MEMORANDUM

Document Number: J-NZ0229-010-M-Rev0

Document Title: Response to S92(1): Consent Application Number RM24.184
12 December 2024

Figure 3. Sulfate versus other water quality parameters, notably iron (Deepdell North, North Gully East, North Gully West, Frasers West, Coronation, Coronation North, and Golden Bar).

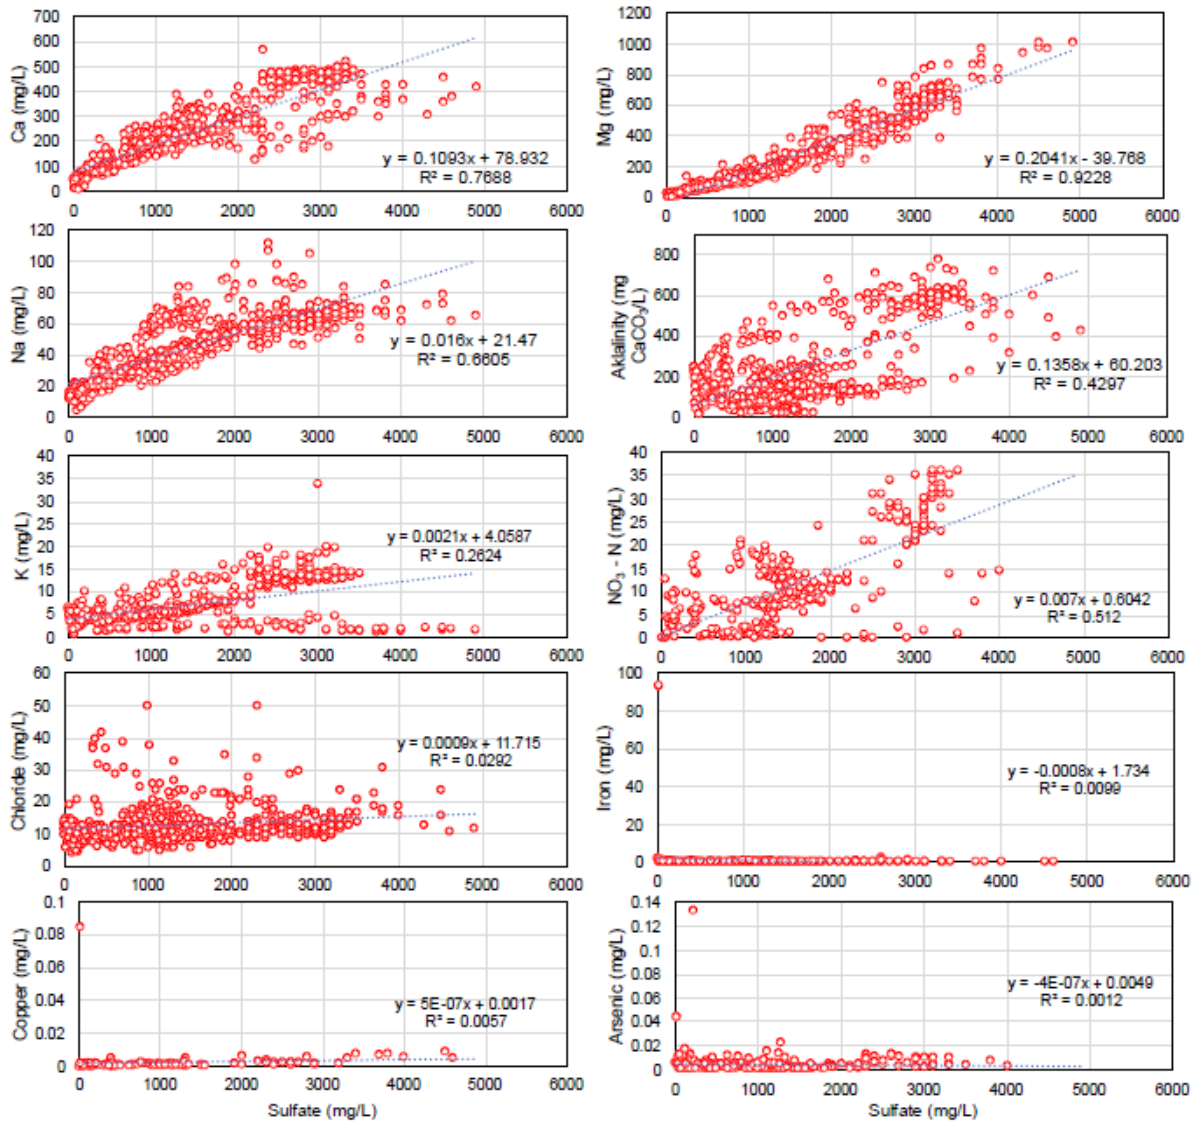
“Has any measurement of sulfides been completed across the water quality monitoring and if so, can further discussion be provided regarding sulfide concentrations in groundwater and surface water?”

WRSs at Macraes are generally formed by disposal methods that do not limit oxygen. The result of this is elevated sulfate concentrations in WRS seepage due to ongoing sulfide mineral (e.g., pyrite) oxidation and low iron (Fe) concentration (Figure 3). If the WRS were sub-oxic or anoxic, then Fe²⁺ could remain in solution at circum-neutral pH and be measured at higher concentrations. The fact Fe is low indicates WRS are unlikely to be anoxic and, therefore, should not contain appreciable amounts of hydrogen sulfide.

Figure 5. Expected Coronation Pit (Stage 5/6 Pit Void) flow path (red line A1-B-A beneath the Trimbells WRS (within the existing gully).

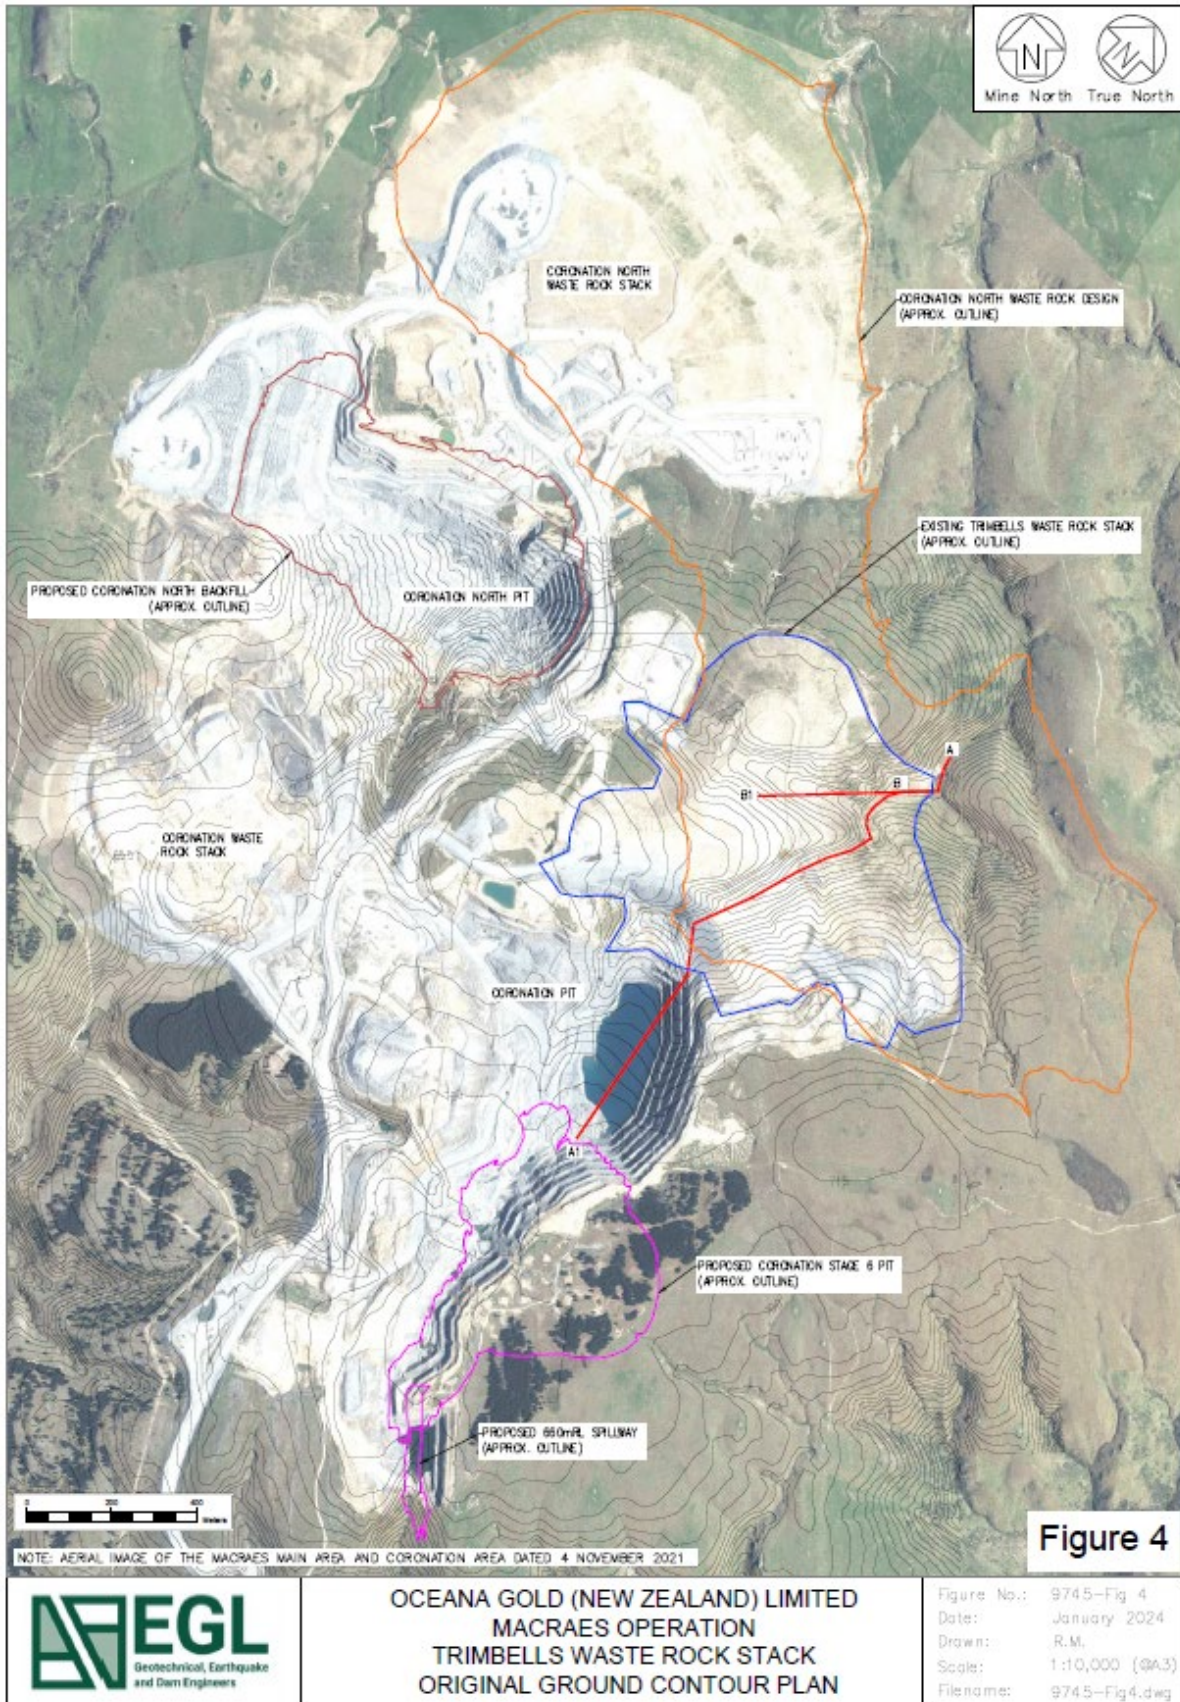
“The GHD (2024) report regarding Coronation assumes that water quality of the overflow from the Coronation Pit Lake through the Trimbells WRS remains consistent and does not deteriorate further before entering the Trimbells silt pond and ultimately Trimbells Gully. Use of source control technologies and treatment has been assumed to prevent and further deterioration of water quality flowing through the Trimbells WRS. What are the realistic limitations of these technologies and what actual deterioration can be expected?”

EGL (2024b) note that the Coronation Pit (stage 5 and 6 voids) will eventually fill up with water at closure with an outlet channel at 660 mRL at the southern end of the Coronation Pit, which will ultimately discharge to Highlay Creek, a tributary of Deepdell Creek. However, there is a low point in the Northern wall of Coronation Pit (637 mRL) that will result in up to approximately 23 m of water depth being locally impounded against the Trimbells WRS. This will result in seepage through the Trimbells WRS, ultimately entering the Trimbells Gully Creek along a ~500 m seepage path. This flow path is shown in Figure 5. GHD (2024a) estimates that the Coronation Pit Lake would eventually reach the RL 660 m and spill into the Deepdell Creek catchment ~200 years after pit closure. Thereafter, the frequency and duration of pit lake spill would be determined by the annual water balance.

GHD (2024a) note the flow rate through the Trimbells WRS from the Coronation Pit Lake will increase from 0 L/s to 0.61 L/s as the pit lake increases in elevation from 637 to 660 mRL and that pit lake seepage from Coronation Pit Lake into Trimbells WRS will occur after 97 years. At this point in time, pit lake water quality is estimated to be 545 mg/L sulfate (MWM, 2024c) and Trimbells WRS seepage is expected to have a sulfate concentration of 3,585 mg/L (GHD, 2024). As noted by the ORC reviewer, there may be deterioration of this pit lake seepage water quality as it passes through the WRS. Further information was requested. A response is provided below.

If the advective ingress of oxygen was prevented along the basal drainage path, within the gully where Coronation Pit seepage would flow (red line in Figure 5), then only the existing stored sulfate load would be mobilised from this zone, which would not be replenished. The quantity of stored sulfate that is present in this basal flow path has been estimated in Table 2 where:
